Meeting Agenda

Historic Zoning Commission

Monday, November 14, 2022

DRAWINGS PROVIDED BY:
ERIC SMITH
VALLEY VIEW BUILDERS, LLC

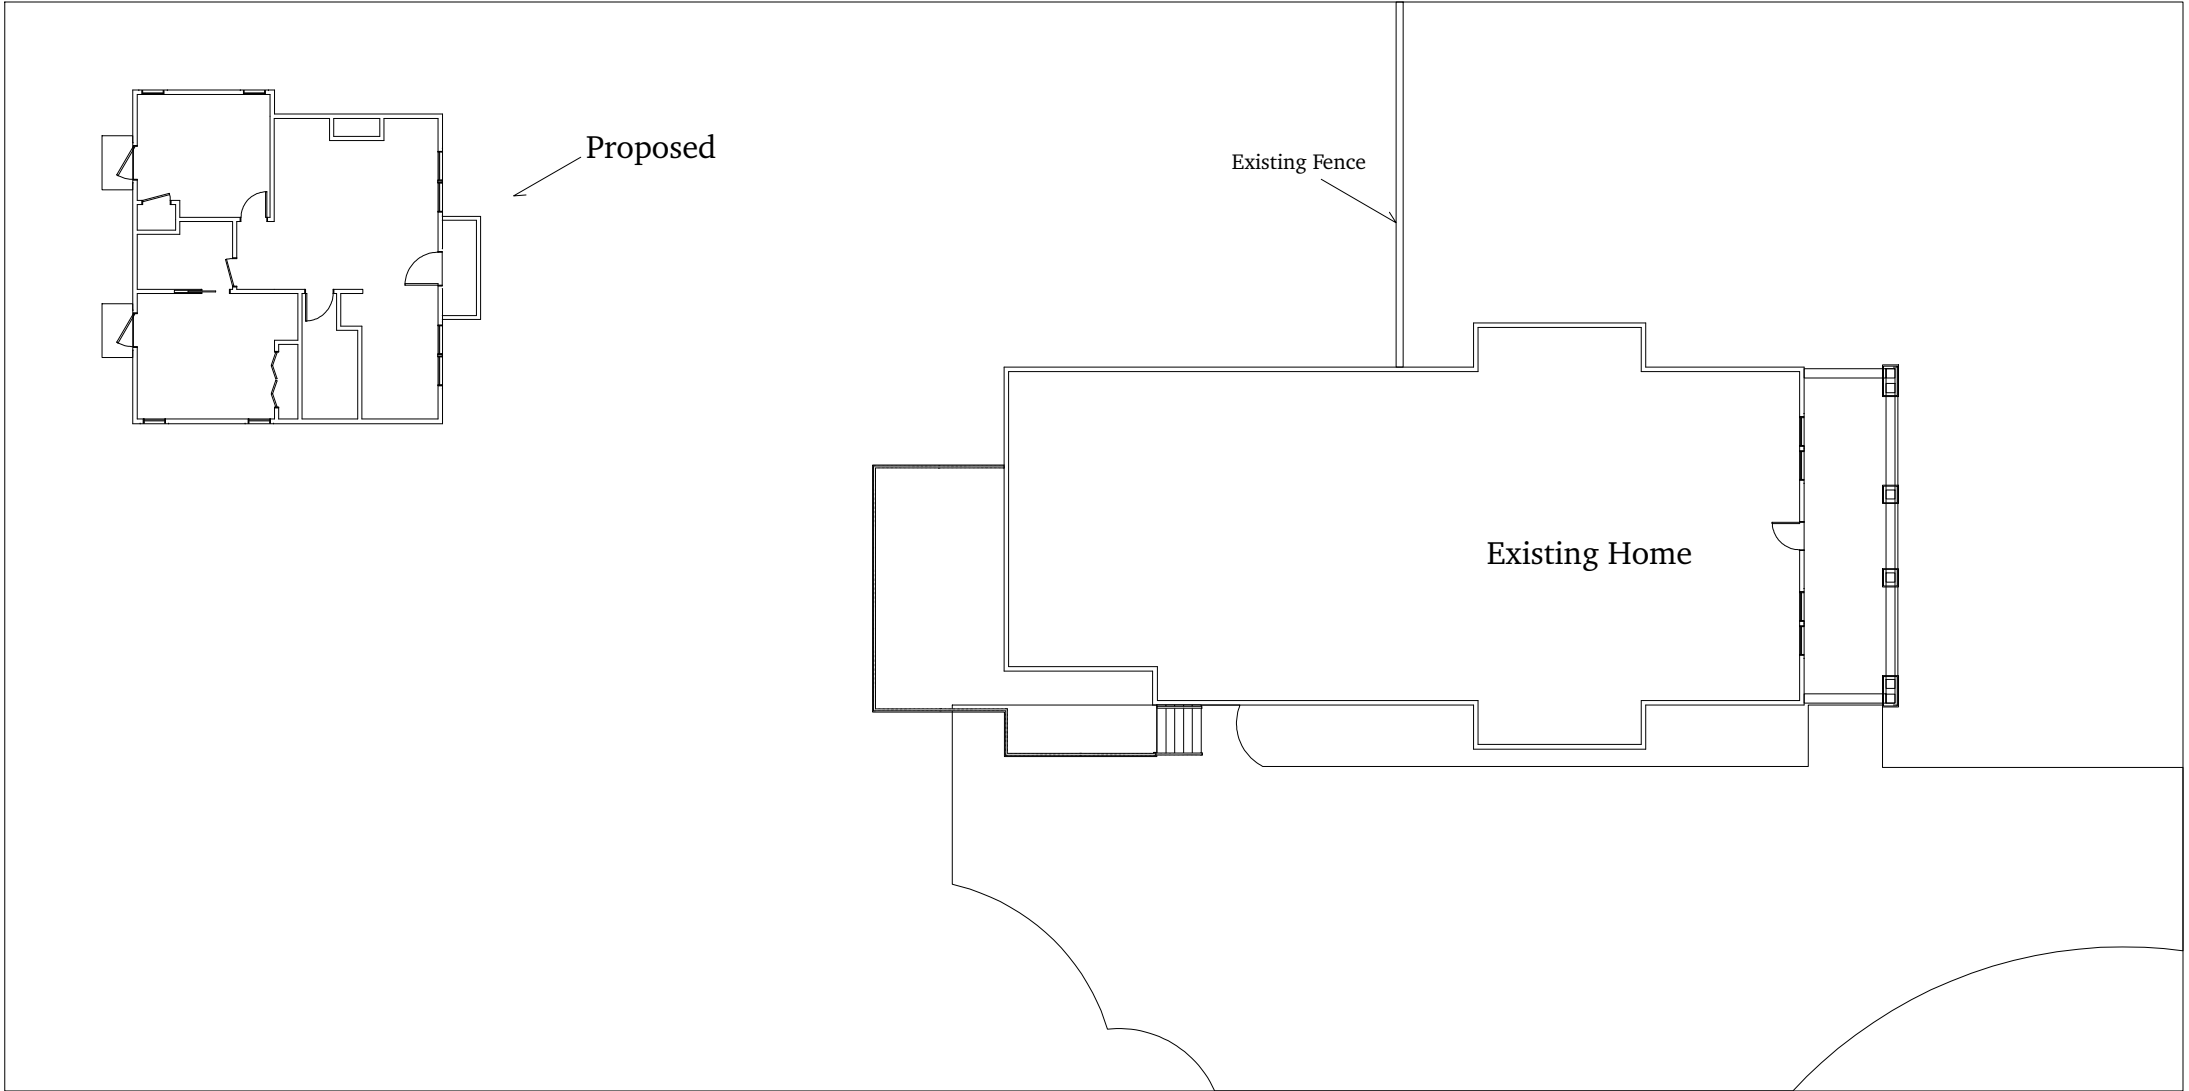
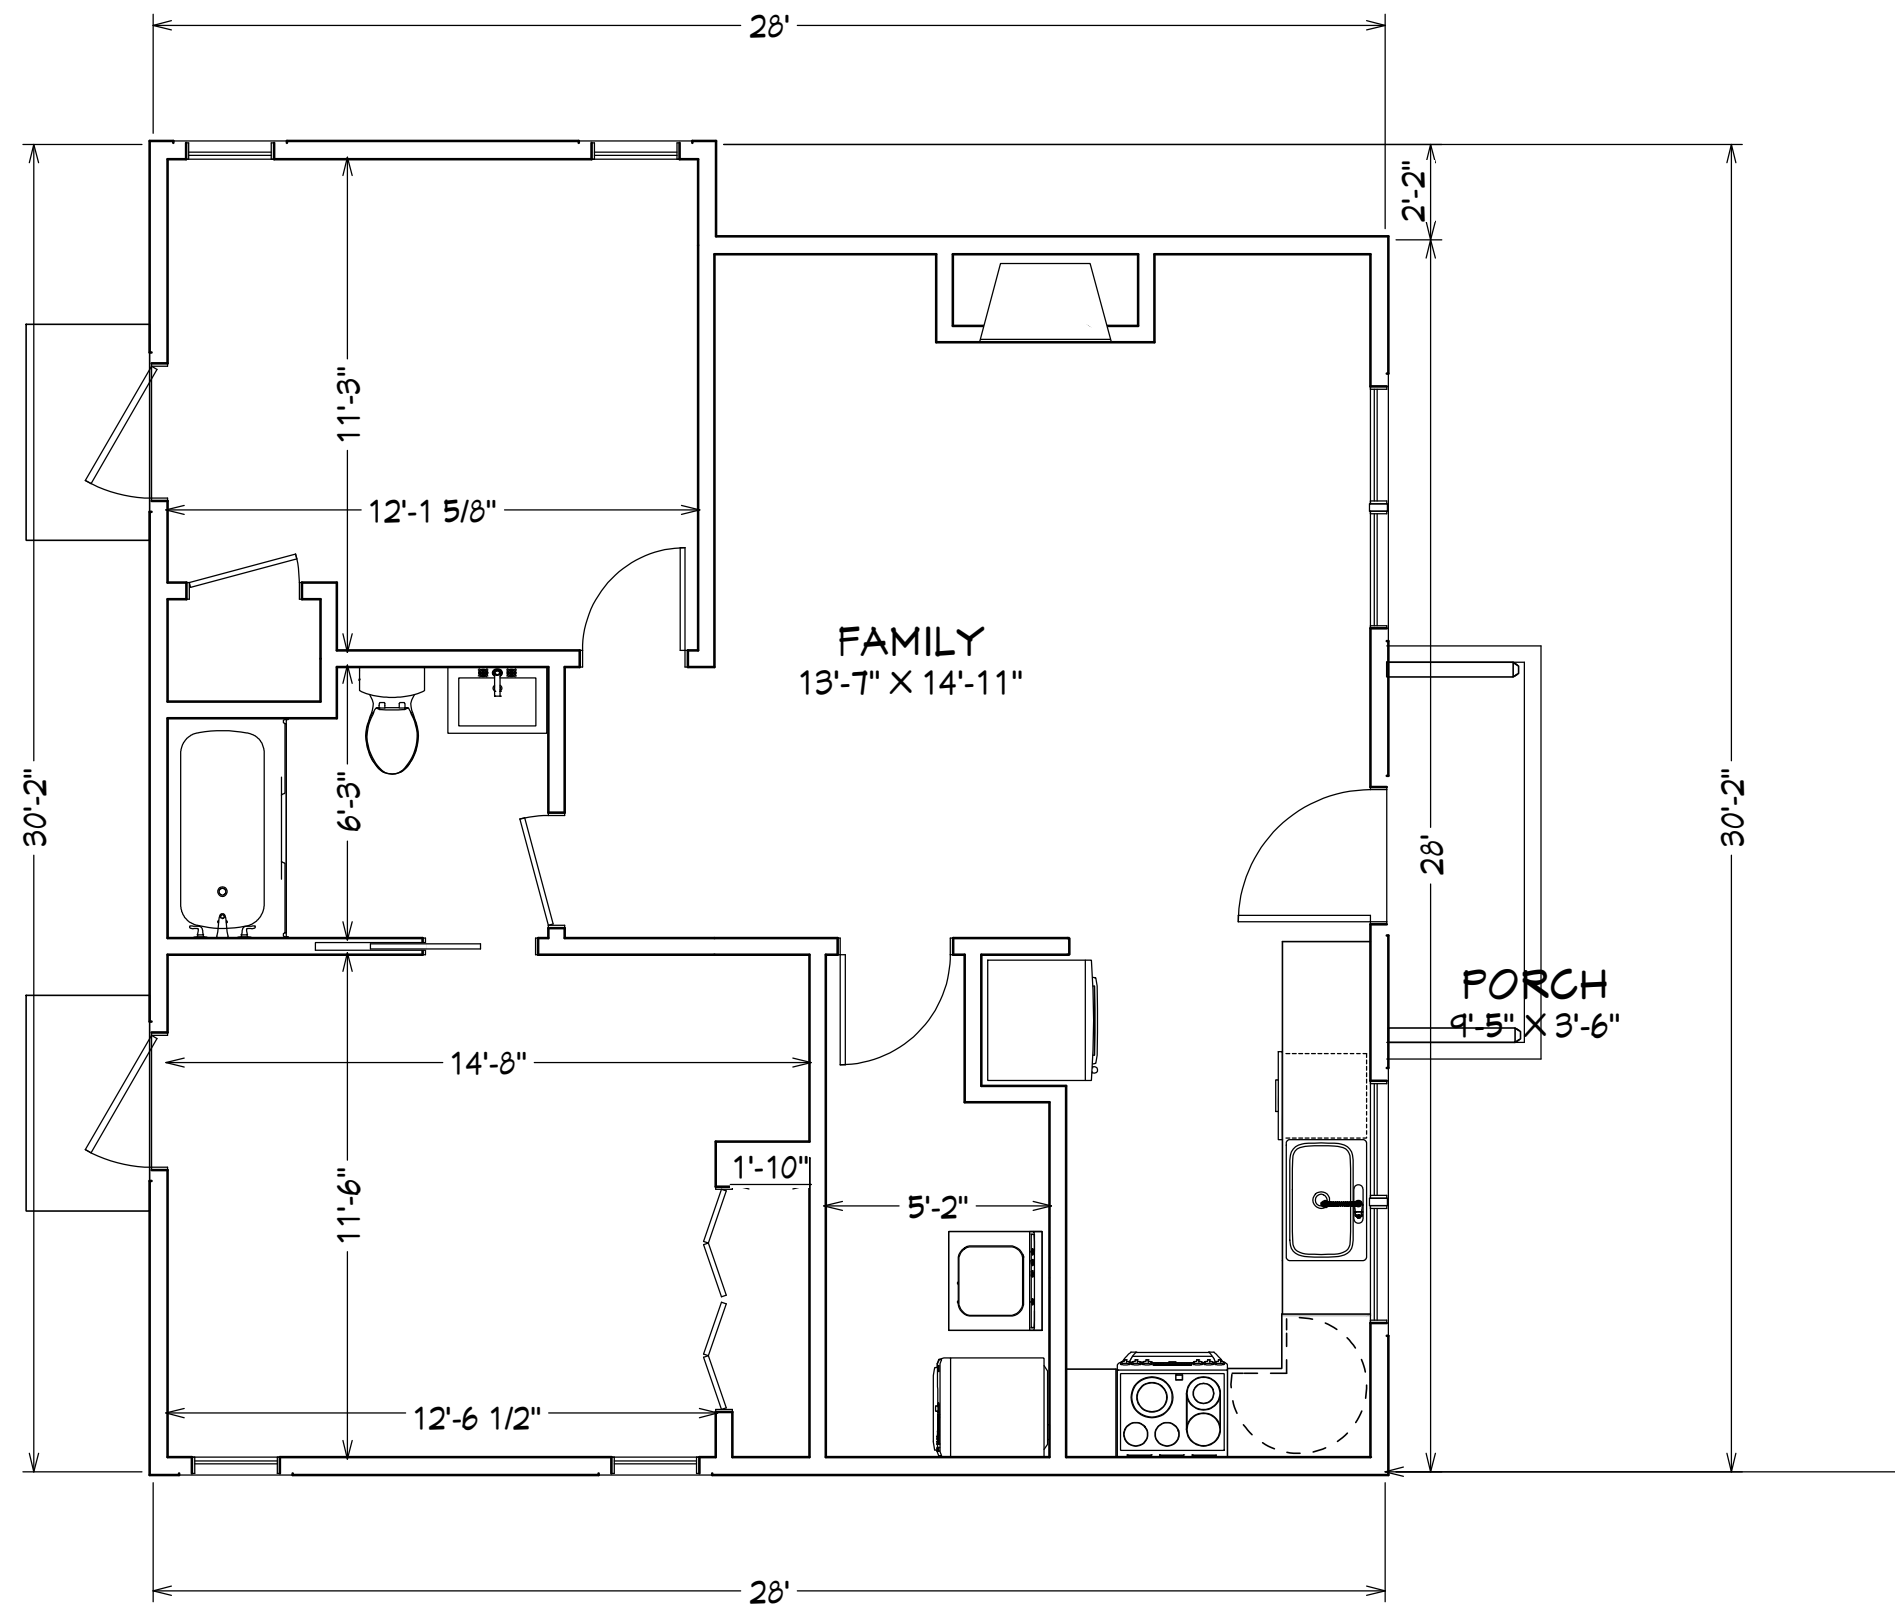
- **Details & Ornamentation:** Details complement, but are less elaborate than, the character of the historic building. The roof form relates to the pitch and shape of the principal building. At the staff and the DRC's recommendation, the original design has been modified to remove a full-width front porch. Instead, the proposal includes a bracketed covered entrance.

2. The right elevation is missing from the COA application. If issued a COA, the applicant must provide the right elevation to the Preservation Planner so it may be reviewed in light of the applicable Guidelines. The right elevation must be approved by the Preservation Planner prior to issuance of a building permit.

3. If issued a COA, the accessory structure windows must have historic profile and dimension and consist of either wood or a composite material with the appearance of wood; the exact window specifications must be approved by the Preservation Planner or the HZC prior to issuance of a building permit.

4. If issued a COA, the application must meet all the requirements of the Building & Neighborhood Services Department prior to issuance of a building permit, and any additional changes to the approved plans must be returned to the Preservation Planner or the Historic Zoning Commission for review and approval.

1 | Water Tower Signs (x2)
3/16" = 1'

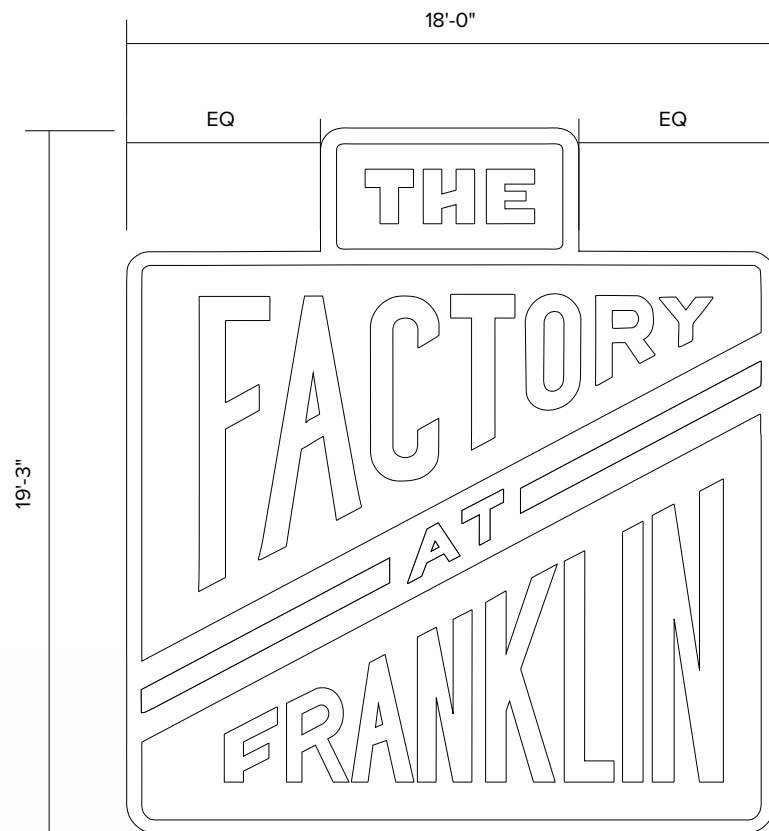
The sign proposal consists of painting two signs onto the tower, on opposite sides. The sign message is proposed to be white, with the tower structure itself to be painted a red/bronze color. The sign message is proposed to measure 346.5 sq. ft. each, in accordance with the Modification of Standard request approved by the Board of Mayor and Aldermen (maximum of 350 sq. ft.).

1. The application must meet all the requirements of the Building & Neighborhood Services Department. No sign permit is required for this proposal.
2. Any changes to the approved plans must be returned to the Preservation Planner for review and approval.
